070009 INFORMATION REPORT  
(NHTSA RECALL NOTICE \_\_\_\_\_ )

## SAFETY RECALL NOTICE NUMBER 070009 (NHTSA RECALL NOTICE \_\_\_\_\_)

**TZ-34 models: Upper turntable bearing bolt torque procedure.**

**Illustration 1**

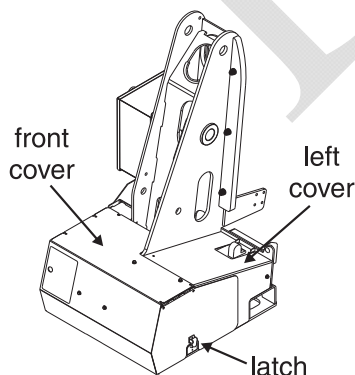
4. Disconnect the batteries and remove the key.
5. Unlatch the left cover and remove the turntable front and left side covers. See illustration 1.
6. Remove the swing motor retaining screws and set the swing motor to the side. See illustration 2.

**Illustration 3**

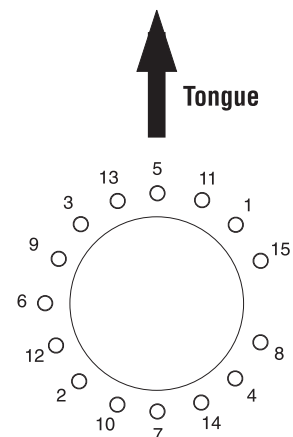
7. Using a torque wrench, torque each turntable bearing bolt (Genie P/N 74712,  $\frac{5}{8}$ -11 x 2.75) to 195 ft-lbs / 264 Nm. Mark each bolt as it is torqued. Use the torque sequence as shown in illustration 3.

**Illustration 6**

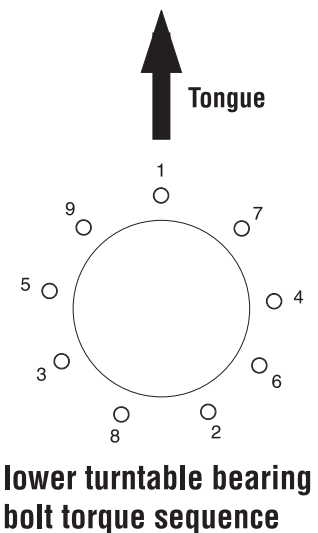
1. Deploy the outriggers and level the machine.
2. Raise the secondary (lower) boom enough so the platform and boom structures will clear the chassis when rotated.
3. Unlatch and lift the left and right turntable tray covers to gain access to the turntable bearing bolts.
4. Using a torque wrench, torque each upper turntable bolt (Genie P/N 74712 -  $\frac{5}{8}$  x 2.75 SHC) to 195 ft-lbs / 264 Nm. Mark each bolt as it is torqued. Use the torque sequence in illustration 4.
5. Rotate the turntable structure to align the lower turntable bearing bolt access hole to each lower turntable bearing bolt. See illustration 5.
6. Using a torque wrench, torque each lower turntable bearing bolt (Genie P/N 74712 -  $\frac{5}{8}$  x 2.75 SHC) to 195 ft-lbs / 264 Nm. Mark each bolt as it is torqued. Use the torque sequence in illustration 6.
